Appeal No: ABP 322787-25

Re: ABP case reference : PL04_322787

Applicant: Tullacondra Green Energy Limited

Proposed wind farm development at Polnareagha, Ardskeagh, Tullacondra, Croughta, Kilmaclenine, Ballyclogh, Knockaunavaddreen, , Copestown, Ballybeg, Baltydaniel East, Twopothouse, Caurraghakerry, Co. Cork .

Map 1

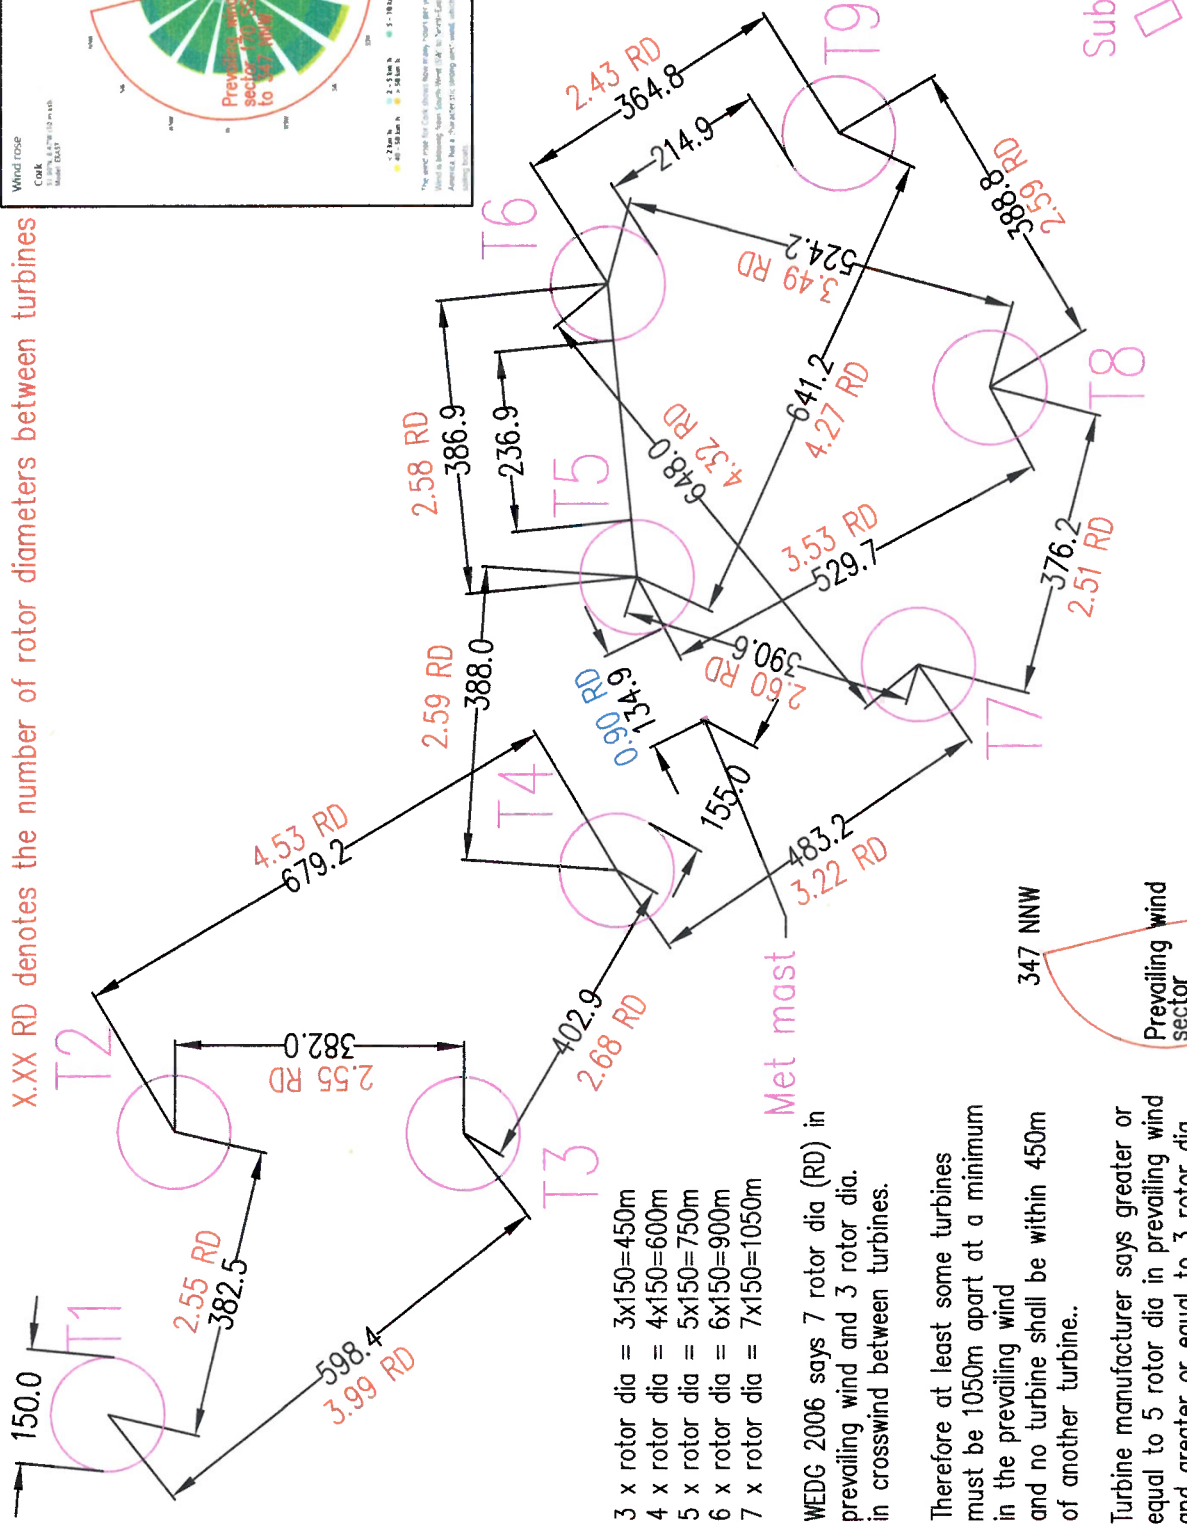
IN ABP case reference PL04_322787 to which this observation refers, the applicant has, as one can see in Map 1, (next page) completely ignored the turbine separation distances from adjacent turbines.

X.XX RD denotes the number of rotor diameters between turbines

WEDG 2006 says 7 rotor dia (RD) in prevailing wind and 3 rotor dia. in crosswind between turbines.

Therefore at least some turbines must be 1050m apart at a minimum in the prevailing wind and no turbine shall be within 450m of another turbine..

Turbine manufacturer says greater or equal to 5 rotor dia in prevailing wind and greater or equal to 3 rotor dia. in crosswind between turbines.

Therefore at least some turbines must be 750m apart at a minimum in the prevailing wind and no turbine shall be within 450m of another turbine..

It is my opinion that the developers will not get a valid warranty for the eventual turbine, after their tender process, for a spacing less than 5 rotor diameters in the prevailing wind direction and 3 rotor diameters in other directions. The layout on Map 1 still shows a significant lack of spacing, using the manufacturers recommendations.

1: The manufacturer's specifications for the particular model of turbines used in their design (Vestas V150 4.5MW) with specific reference to the minimum separation distances from turbine to turbine within the windfarm (not windfarm to windfarm).
(Turbine manufacturers recommend separation distances to avoid excess turbulence, wind shear, noise and other impacts on the integrity of the turbines).
This is to enable them provide a warranty for the turbine being used.
